MEMORANDUM

PND Project No: 154038

Subject: Kalama Marina Renovation

Figure 1. Department of Ecology's Flood Hazard Areas of this Project Site.

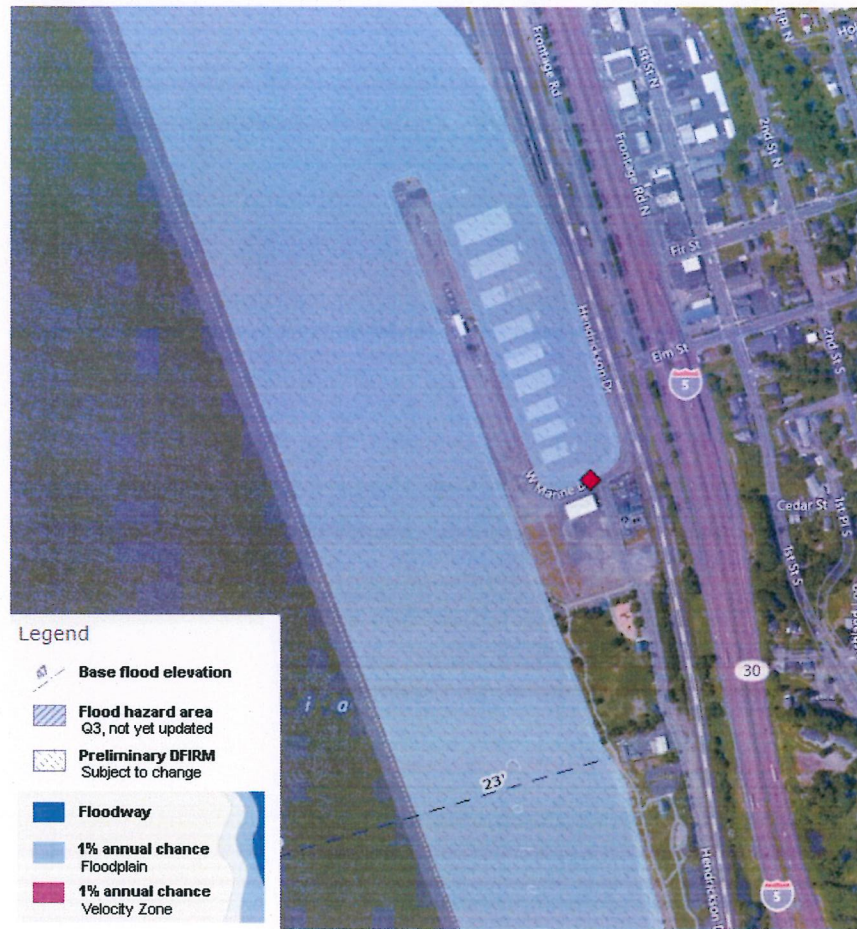
Comment No.	Comment/Request	Response &/or Description of Revision
1	Plans and specifications for the new fueling dock	Design in progress. Plans and specifications will be provided upon completion.
2	Please either submit a Floodplain Development Permit (FDP) application (or provide justification for why one is not required). Although no “structures” are proposed, the scope of work falls under the City’s definition of “development” per KMC 14.16.030. Additional materials needed besides the application form is some substantiation of how docks, piles, and bridge abutments will be designed to withstand flood flow and hydrologic pressure related to debris hangups, per KMC 14.16.100(F).	<p>Please see the attached FDP below.</p> <p>The docks and piles, will be designed to withstand flood flow and hydrologic pressure related to debris hangups, per KMC 14.16.100(F).</p> <ol style="list-style-type: none"> 1. There are no bridge abutments included as part of this projects. 2. The BFE change caused by new piles is negligible. 3. New piles will be sized and designed to withstand a BFE event and the new piles will be taller than the timber piles. 4. Hydrologic pressure from debris hangups is expected to be minimal due to the location

Of greater importance is the ability of new construction to resist hydrodynamic and hydrostatic loads during a flood event. Hydrodynamic forces caused by debris hangups and other drag forces during a flood event are anticipated to be small, due to the location of the project within a

protected basin in the Kalama Marina. Figure 1, below, shows the protection offered to the basin by the breakwater during a flood event. The project will be designed such that the forces exerted on the piles by the drag of the floating elements of the marina will not cause the piles to fail.
